CJC:70002

FIXED SELF-TEST PRISM  
AND IMPROVED TELESCOPE SEAL

CJC:70003

PROPOSED INCREASED FIELD OF VIEW

FIGURE 5 - PRESENT AND MODIFIED OPTICAL SYSTEMS

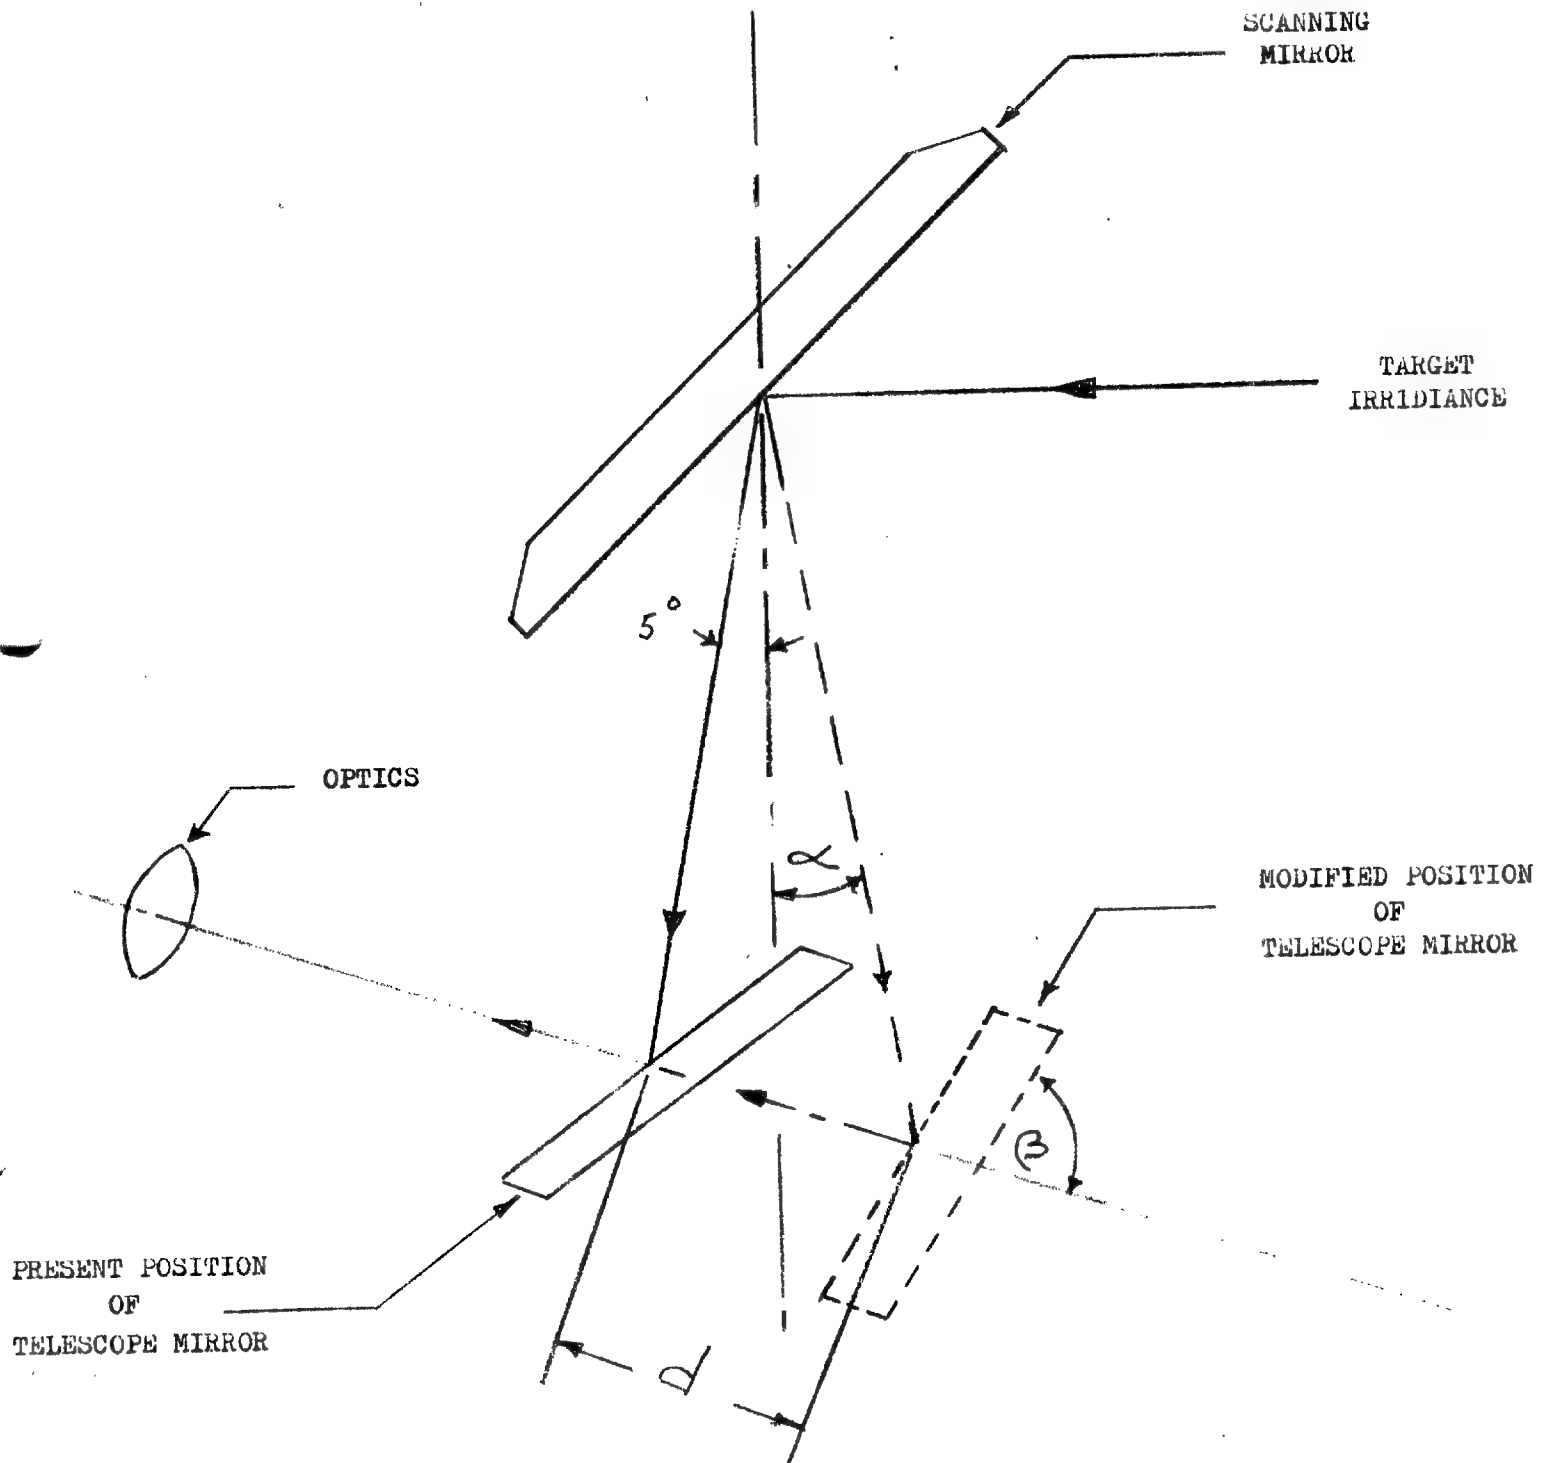
In the present system the telescope reflecting mirror is located  $5^{\circ}$  behind the vertical axis of the scanning mirror as shown in Figure 5. This causes an azimuth look angle of less than the azimuth mechanical angle according to the equations

A review of the scan pattern equations reveals that the azimuth look angles can be increased by repositioning the telescope reflecting mirror in front of the vertical axis of the scanning mirror. The azimuth look angle equation changes from

where  $\alpha$  is the offset angle in front of the vertical axis of the scanning mirror as shown in Figure 5.

For an offset angle  $\alpha$  of  $+5^{\circ}30'$  the telescope reflecting mirror had to be moved a distance  $d$  of 0.578 inches down the axis and tilted to an angle  $\beta$  of  $53^{\circ}15'$  with respect to the axis.

FIGURE 6 - SCAN PATTERNS

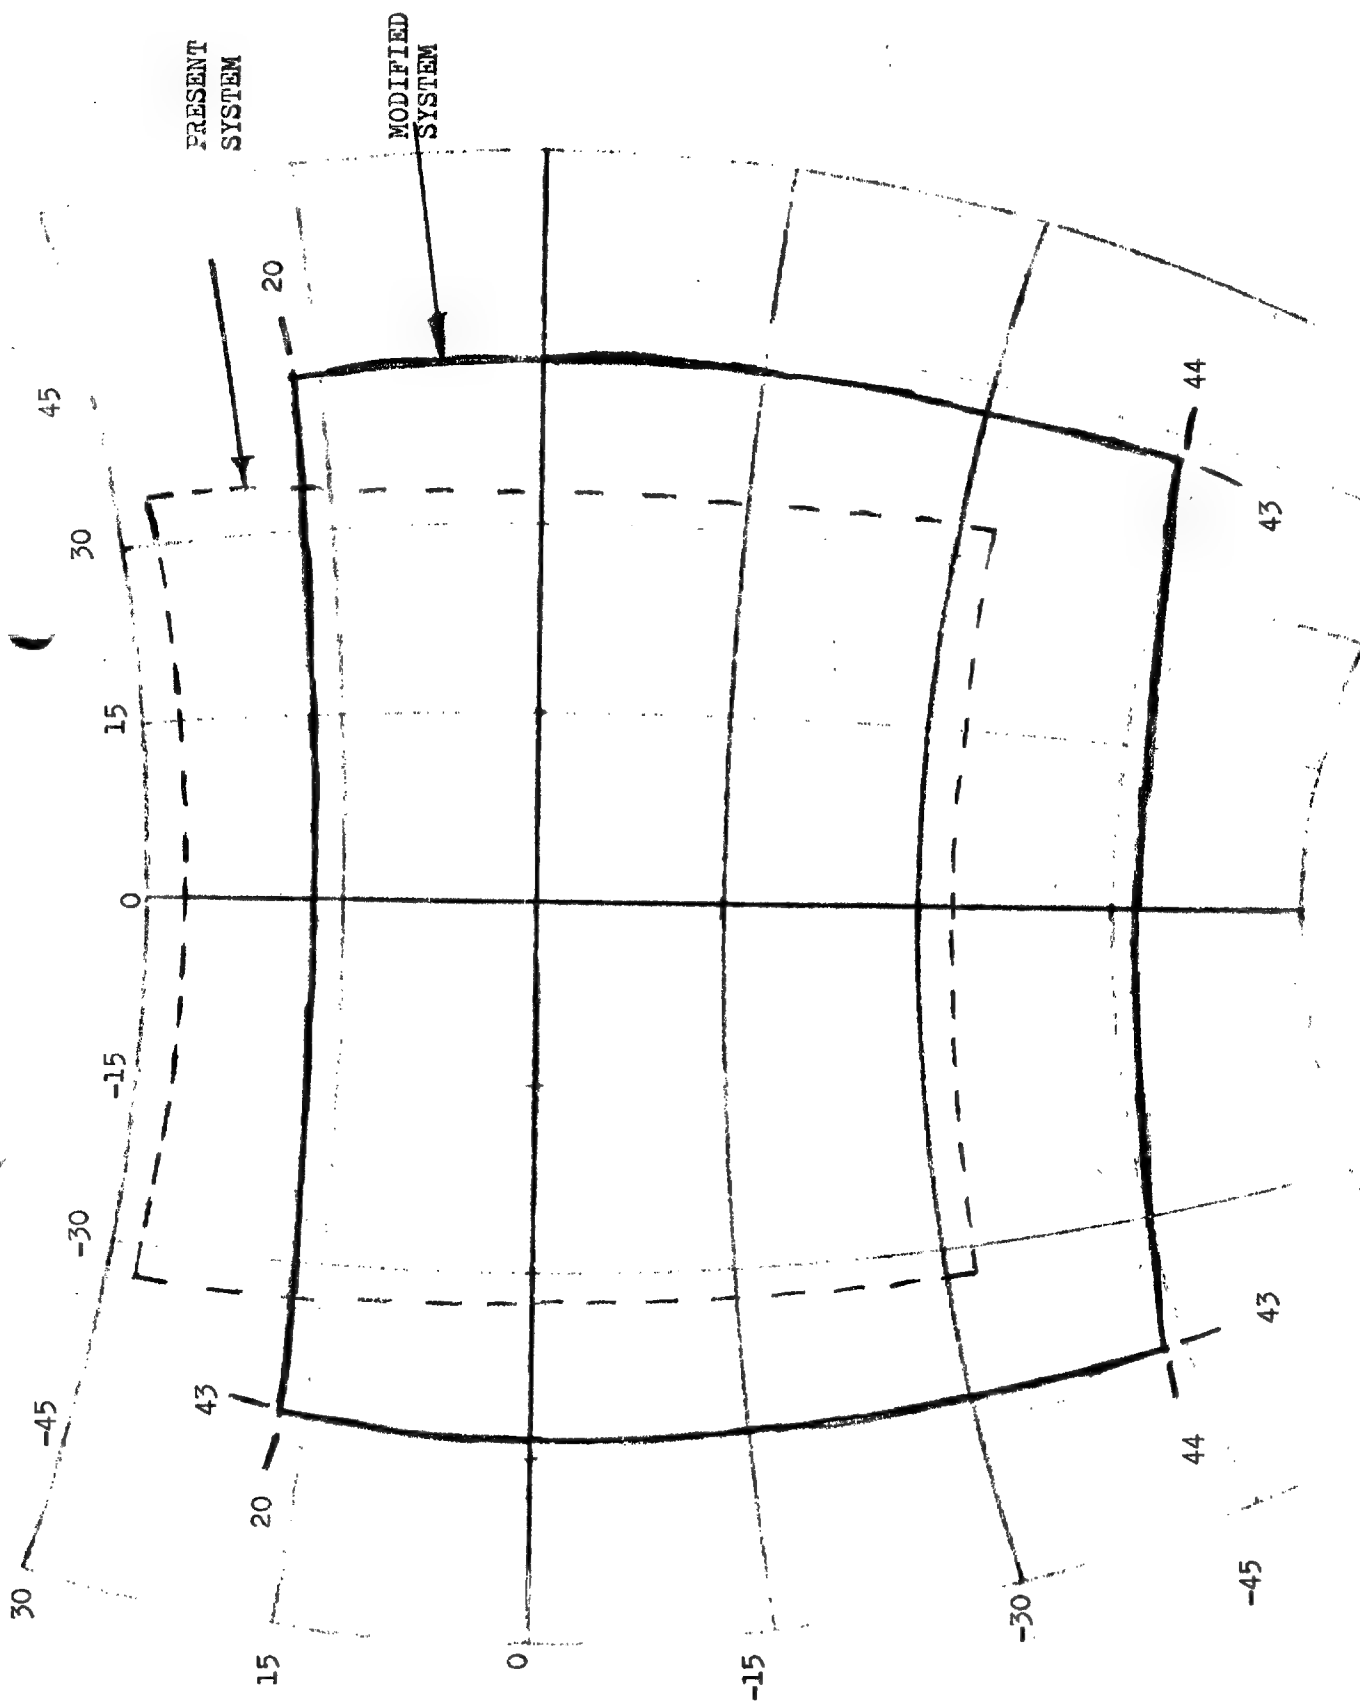
Figure 6 shows the scan pattern of the modified optical system along with the pattern of the present system displayed on a spherical coordinate system.

The entire modified pattern is shifted down  $10^{\circ}30'$  from the original pattern due to the change in offset angle of the telescope reflecting mirror.
